**Subject:** Submittal of Replacement Pages to Update the NAC-UMS<sup>®</sup> FSAR from Revision 4 to Revision 5 (Docket No. 72-1015)

**10 CFR 72.48 Evaluation Summary Report**

**NAC-UMS<sup>®</sup> Universal Storage System  
(Docket No. 72-1015)**

PROJECT 790 DRAWING 583 REV 8

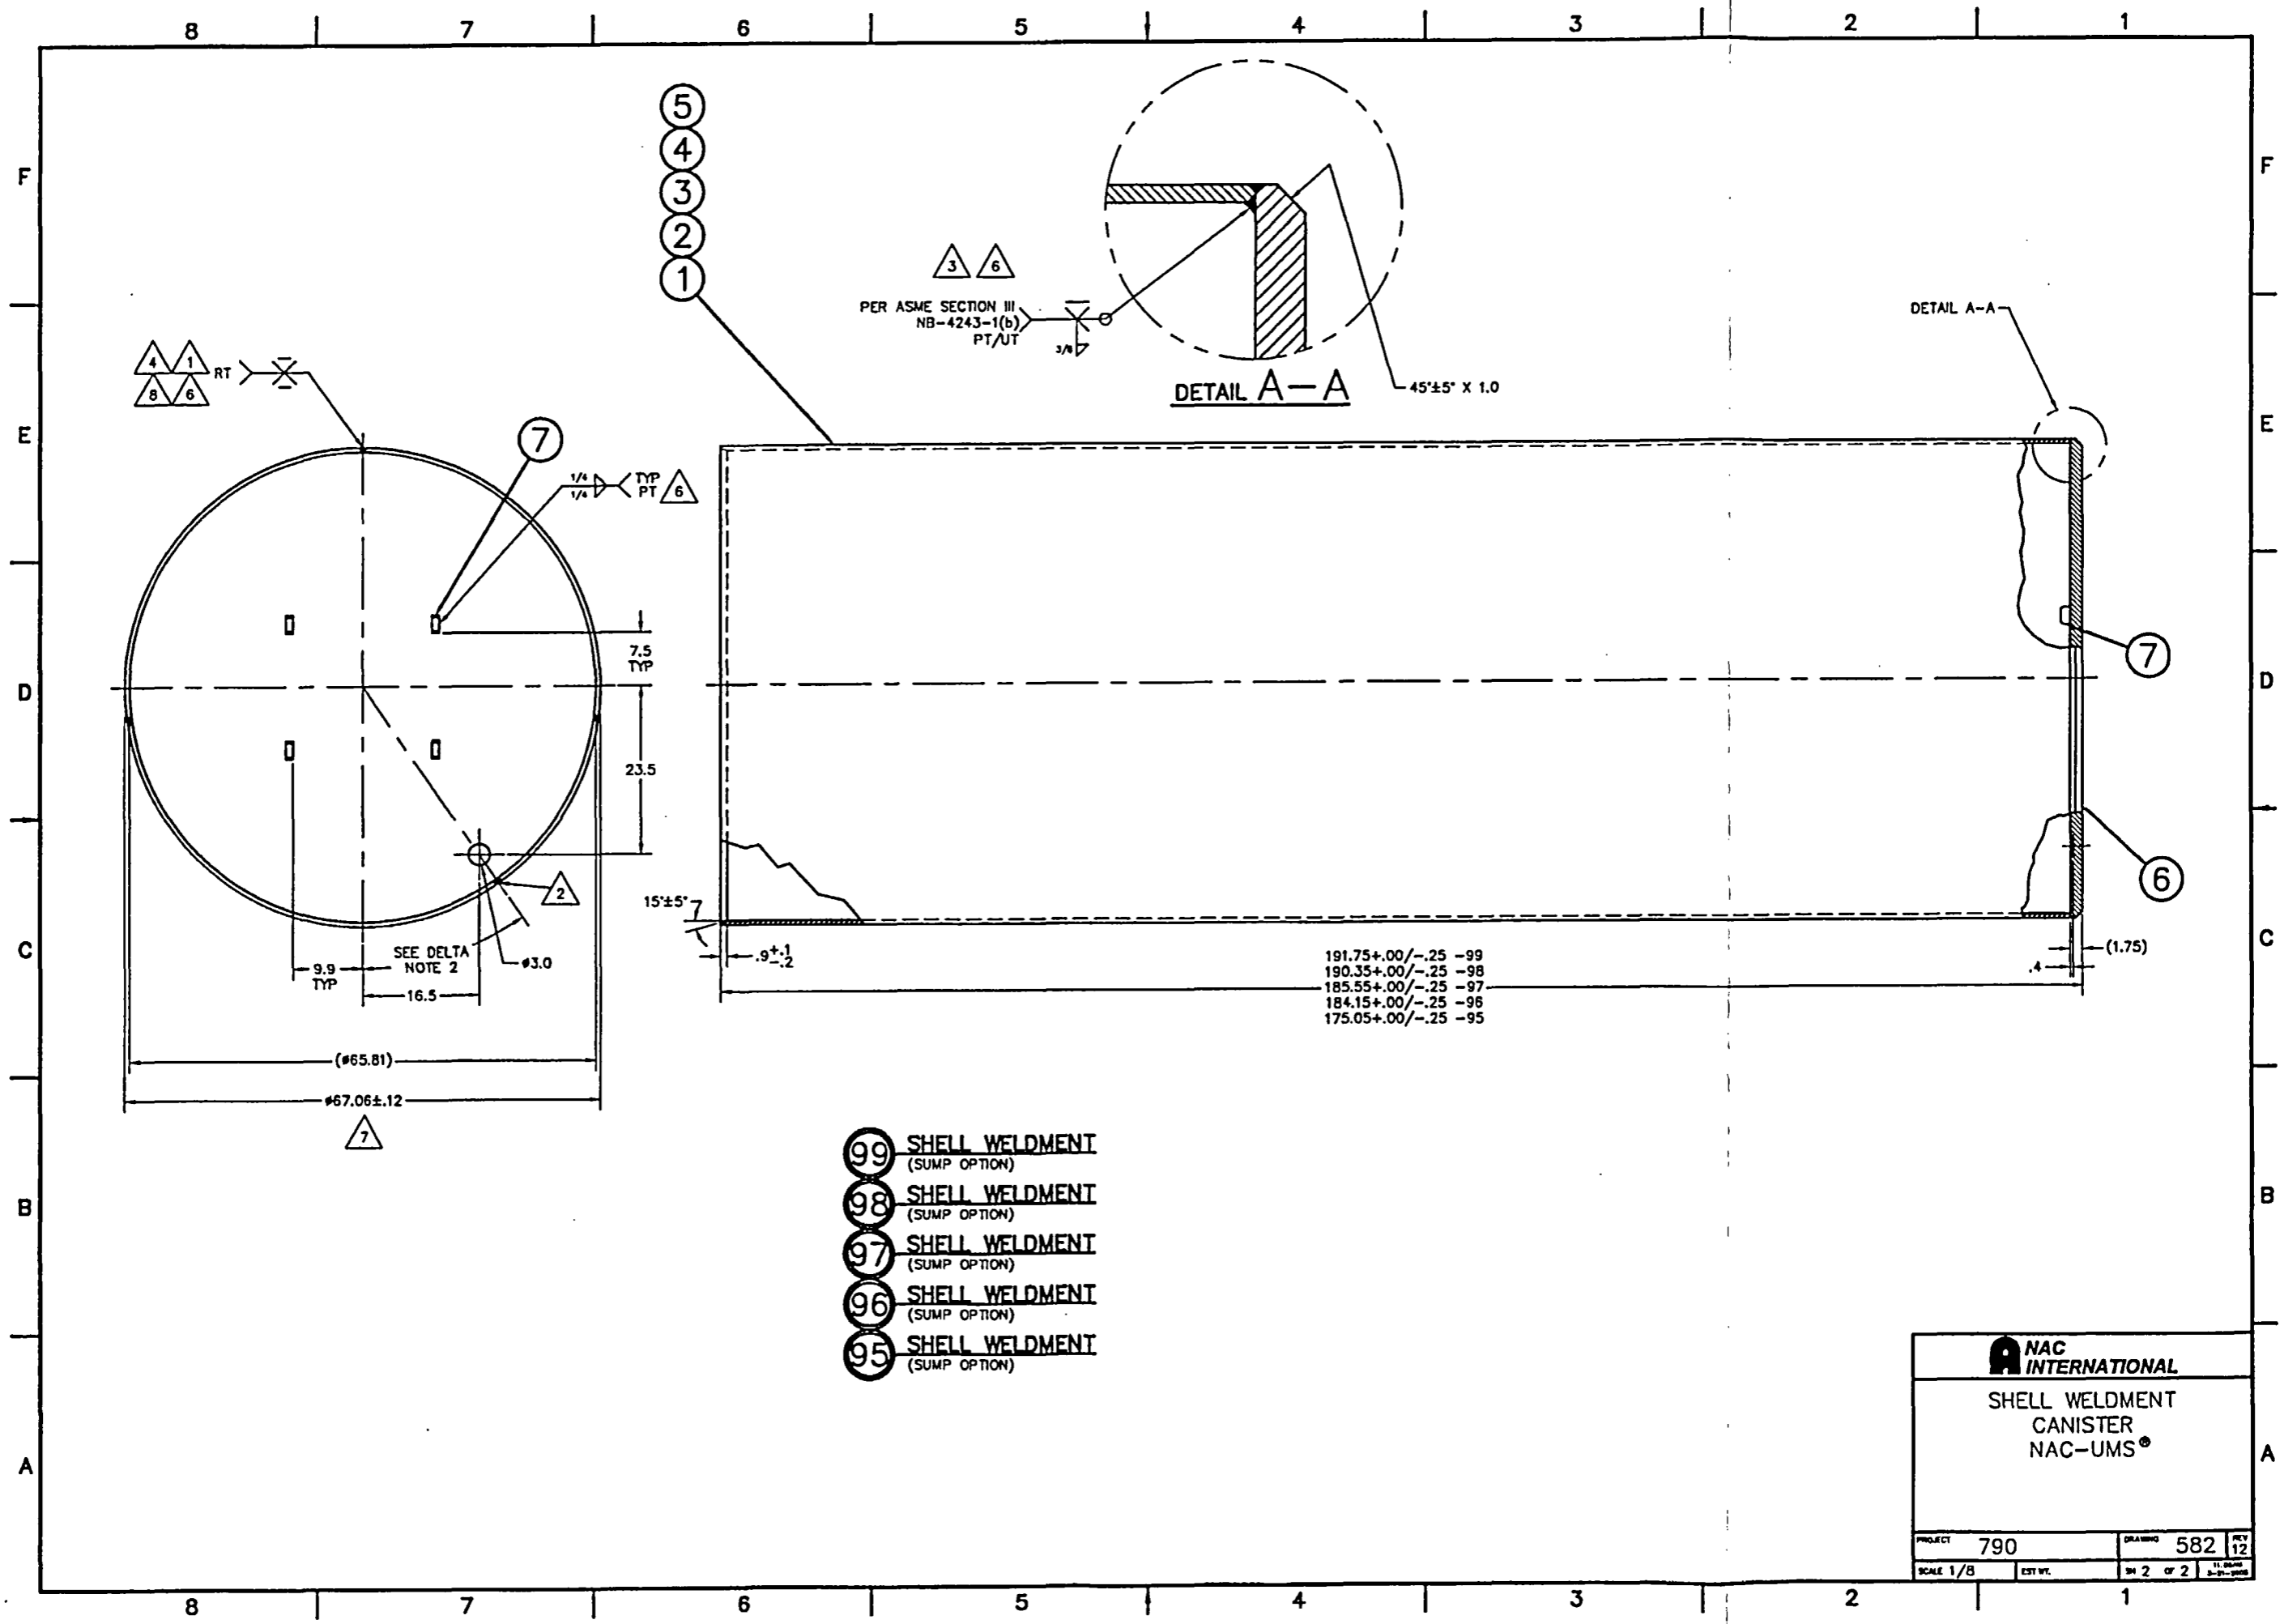
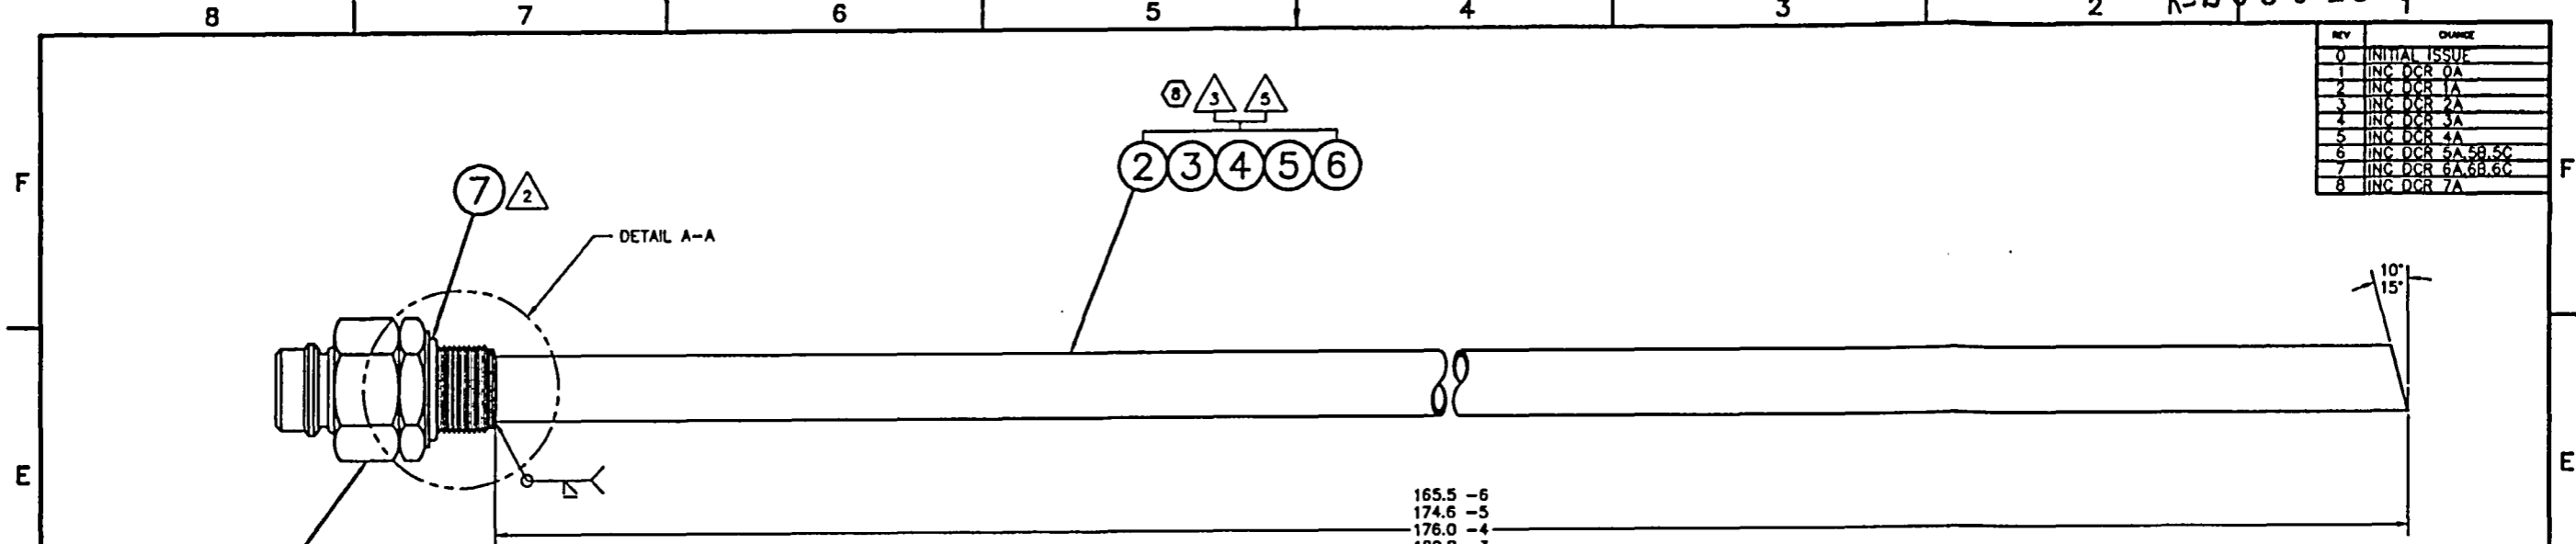
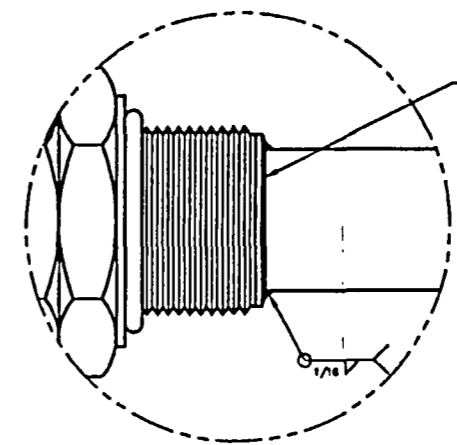
1. Added a new Delta Note 3 to BOM and balloon callouts for Items 2-6, Tube: "Minor surface indentations and/or dimensional deviations are acceptable for Items 2-6, Tube."
2. Changed BOM Items 2-6, Specification: IS) COML; WAS) ASTM A249/A213.
